Municipal Building, 11th Floor
AHU 6-7
Cooling Coil Replacement
841 North Broadway
Milwaukee, Wisconsin

Addendum No. 1

Project: City of Milwaukee AHU-6/7 Cooling Coil Replacement

DRAWING CHANGES

M1.11

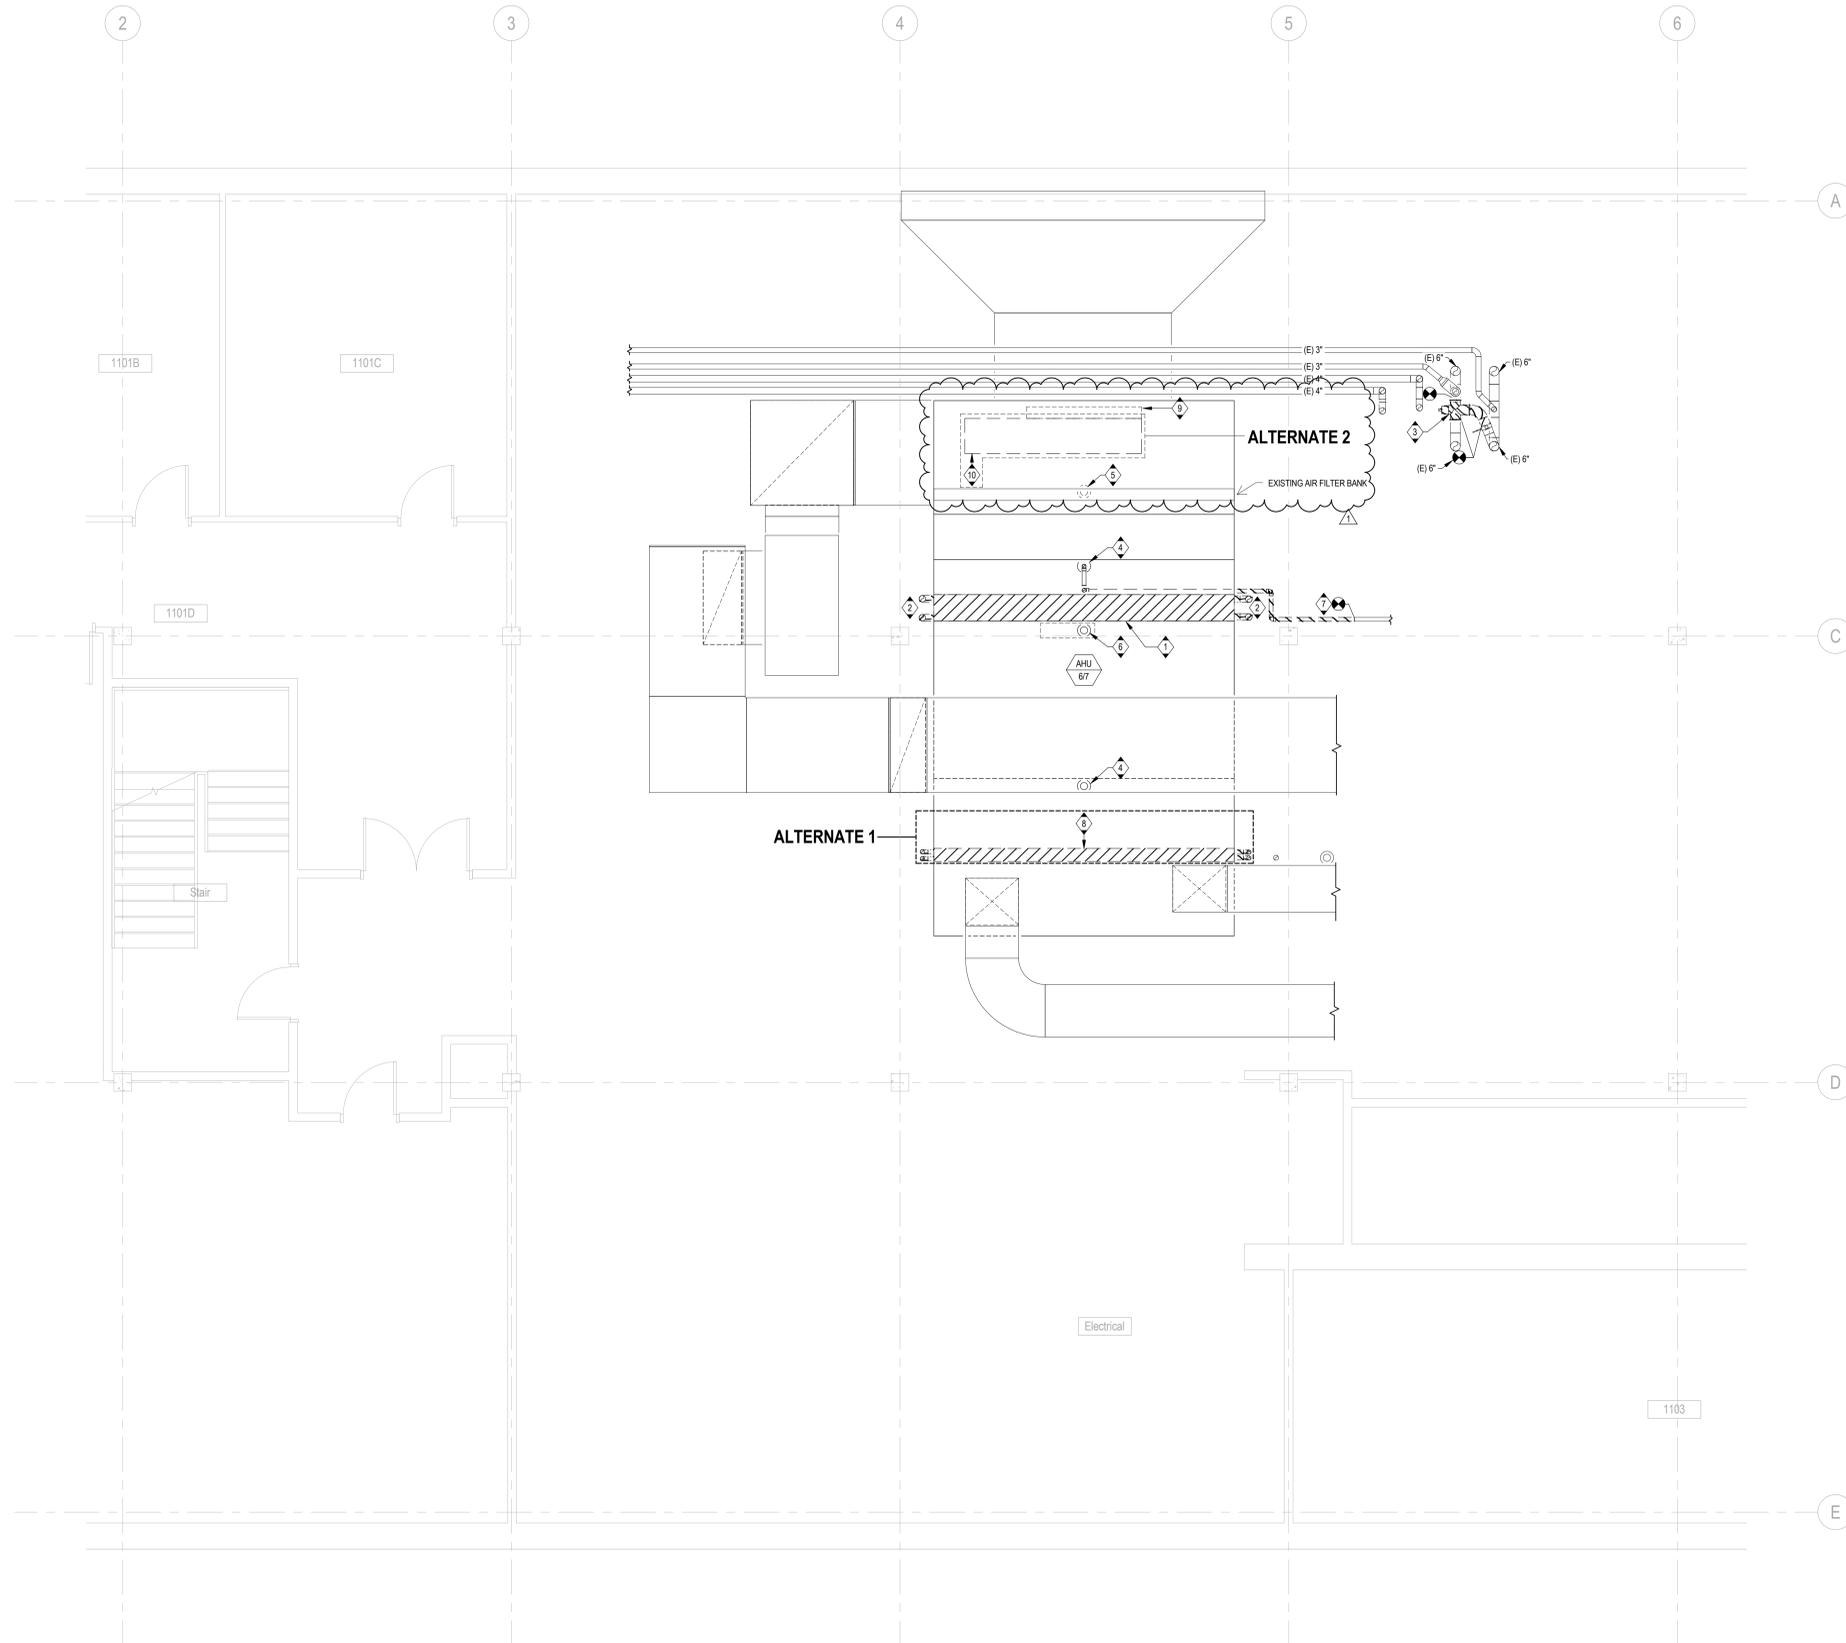
<u>Sheet</u>	<u>Description of Revisions</u>
M1.11	Add the removal of an existing deflector box located over the existing heat reclaim coil in the mixing box section of the air handling unit. Refer to attached updated drawing M1.11
M2.11	Revise the location of the new baffle/diffuser plate in the existing air handling unit 6/7 to show the location of the baffle/diffuser upstream of the air filter section in the air handling unit. Refer to attached updated drawing M2.11
